# UNITED STATES PATENT AND TRADEMARK OFFICE

APPLICATION NO.	FILING DATE	FIRST NAMED INVENTOR	ATTORNEY DOCKET NO.	CONFIRMATION NO.
10/646,863	08/25/2003	Tae Hwan Jung	1594.1274	1800

# Office Action Summary

## **DETAILED ACTION**

Cherry '747 Figure 7

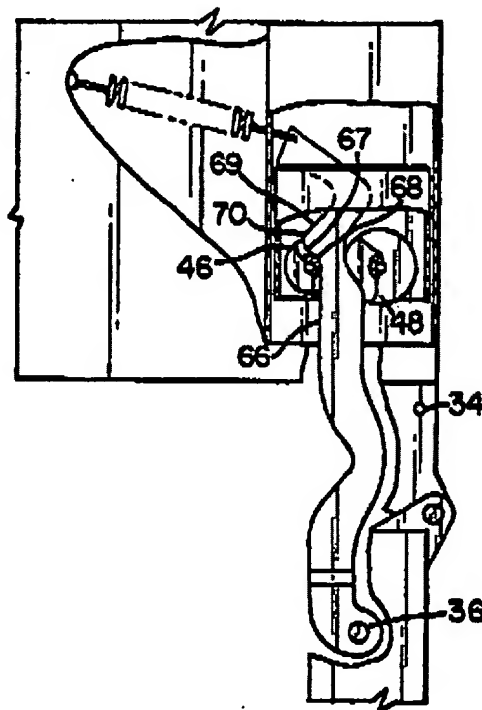
4. Claims 1, 2, 6, 7-17, 28, 29, and 34-44 are rejected under 35 U.S.C. 103(a) as being unpatentable over U.S. Patent 5,220,747 to Cherry in view of U.S. Patent 6,711,778 to Sparkman.

5. Cherry '747 discloses a door control device for a refrigerator (10) having a refrigerator door (14). A movable body (38) is coupled to the refrigerator door (14). Wherein the movable body (38) is arranged to move in opposite directions in accordance with opening and closing actions of the refrigerator door. A control unit (54, 54a) controlling an opposite directional movement of the movable body in a multi-stage manner.

Cherry '747 Figure 4

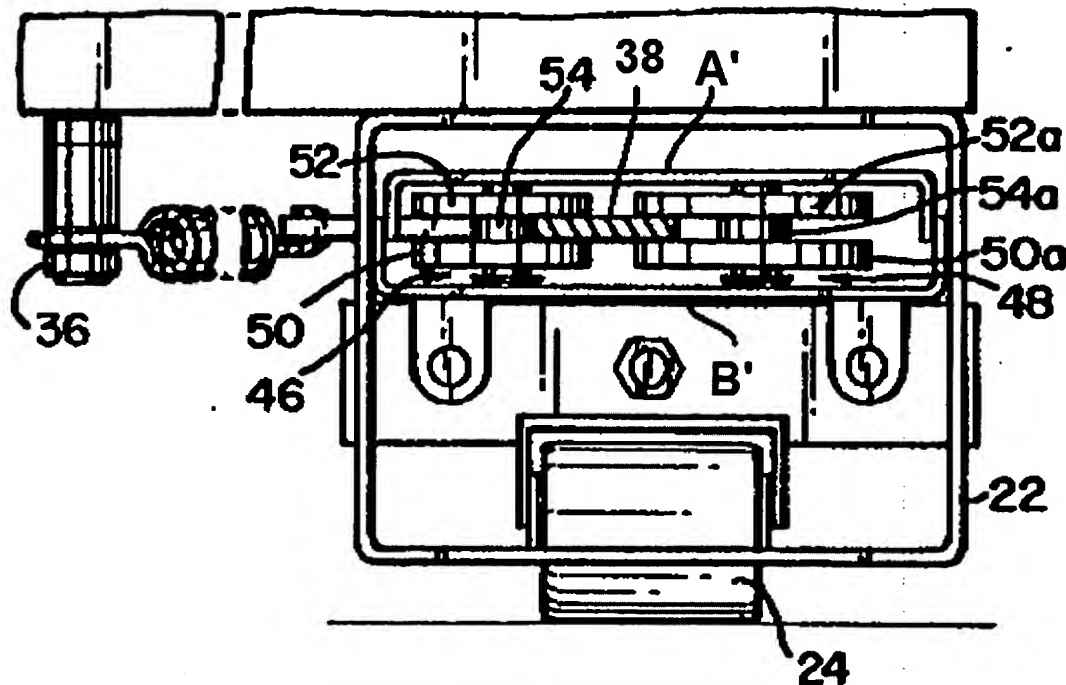
6. Regarding claims 14 and 28, the refrigerator (10) is defined as a cabinet (11) with a storage compartment (12). The door (14) is hinged to the cabinet (11) to close the storage compartment (12). The device is disposed in a leg casing (22) at a lower portion of the refrigerator (10) as best shown in figure 1.

7. Regarding claims 2 and 29, a guide element (50,52,50a, 52a, A', B') contains the movable body (38) and guides the opposite directional movement of the movable body.

8. Regarding claims 6 and 34, the movable body (38) is provided with a plurality of grooves (65,68) formed along a longitudinal side surface.

9. Regarding claims 7 and 35, the control unit (54,54a) comprises a locking unit (54, 54a) selectively engaging with the plurality of grooves provided to the movable body.

10. Regarding claims 12 and 40, the grooves (65,68) of the movable body (38) are smoothly curved to form a waved configuration.

Sparkman '778 Figure 2

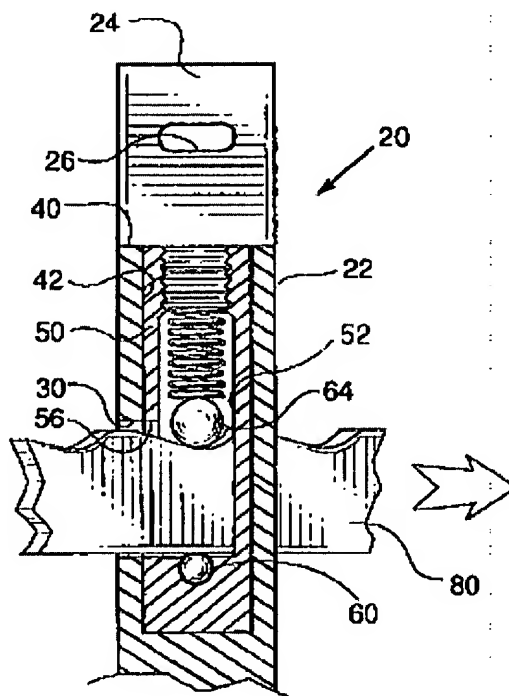
12. Sparkman '778 discloses a locking unit (64) selectively engaging with the plurality of grooves (88,90,92, 94) provided to the moveable body (80) to hold the door (4) in various open positions. An elastic member (66) elastically supports the locking unit (64). The locking unit (64) comprises a retractable roller (64) selectively seated in the grooves (88,90,92) of the movable body (80) during a movement of the movable body (80). The roller (64) is perpendicular placed relative to the movably body (80), and

wherein the roller (64) is elastically retractable. The control unit (64,66) is disposed in a control chamber (50), which is defined in a separate member (22) at a predetermined position on the sidewall (2) and is integrally fastened to the sidewall (2) with screw (28). At the time of the invention it would have been obvious for a person of ordinary skill in the art to modify the device of Cherry by adding one more groove to the moveable body and by adding the locking unit and control chamber of Sparkman to provide a plurality of stop positions.

Koopman '619 Figure 3

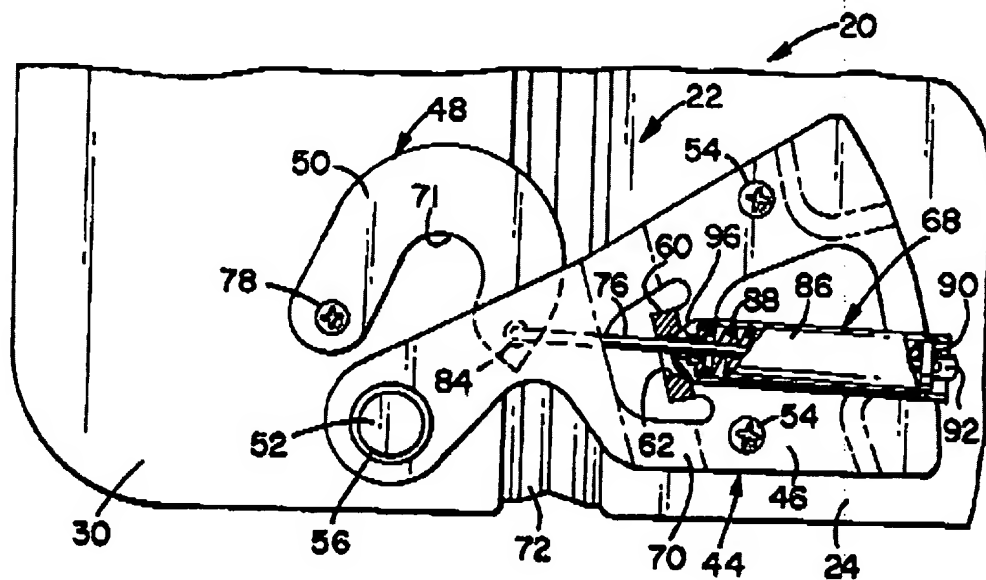
16. Claims 3-5 and 30-33 are rejected under 35 U.S.C. 103(a) as being unpatentable over U.S. Patent 5,220,747 to Cherry in view of U.S. Patent 6,711,778 to Sparkman as applied to claim 1 and 28 above, and further in view of U.S. Patent 5,896,619 to Koopman. Cherry '747 in view of Sparkman discloses every element as claimed and discussed above and Cherry also discloses a hinge bracket (28) mounted to the door. Cherry '747 in view of Sparkman does not disclose expressly a link bar. Koopman '619 discloses a link bar (50) hinged at a first end (84) thereof to an end of the movable body (76), and connected at a second end (80) thereof to the refrigerator door (30). The link bar (50) is hinged at the refrigerator door (30). The link bar (50) is further hinged to the

refrigerator door (30) in a position spaced apart from the rotating axis (52) of the refrigerator door (30) by a predetermined distance in a radial direction from the rotating axis (52). At the time of the invention it would have been obvious for a person of ordinary skill in the art to take the device of Cherry and add the link bar of Koopman so that the door can achieve a greater range of motion.

Jeynes '551 Figure 1

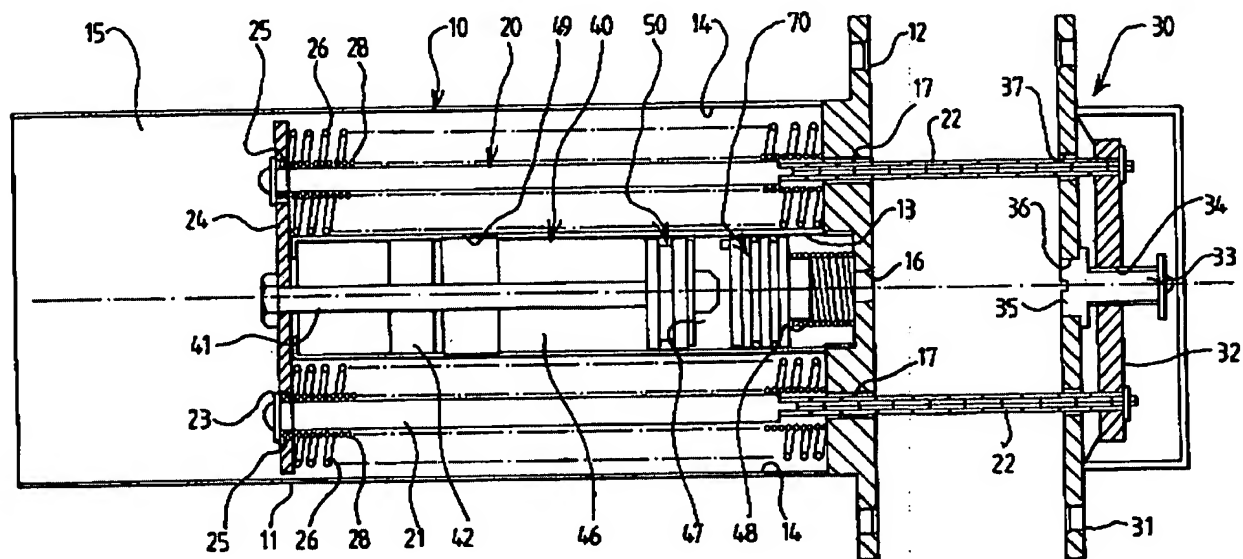
17. Claims 18-27 and 45-53 are rejected under 35 U.S.C. 103(a) as being unpatentable over U.S. Patent 5,220,747 to Cherry in view of U.S. Patent 6,711,778 to Sparkman as applied to claims 1 and 28 above, and further in view of U.S. Patent 5,706,551 to Jeynes. Cherry '747 in view of Sparkman discloses every element as claimed and discussed above and Cherry also discloses tension spring (56) attached to the rear of the moveable body (38). Cherry '747 in view of Sparkman does not disclose expressly a dampening unit. Jeynes '551 discloses a dampening unit (10) to close a

door. The dampening unit (10) uses an elastic support unit in the means of two parallel compression springs (26) to drive the shafts (22) into the body. The compression springs are connected to a support member (30) by shafts (22). The dampening unit (10) uses a hydraulic damper (40) to dampen the rate of rearward movement during closing action, thus retarding energy generated from the door. At the time of the invention it would have been obvious for a person of ordinary skill to take the device of Cherry and replace the tension spring with the dampening unit of Jeynes by attaching the support member to the moveable body so that the closure rate of the door is controlled.
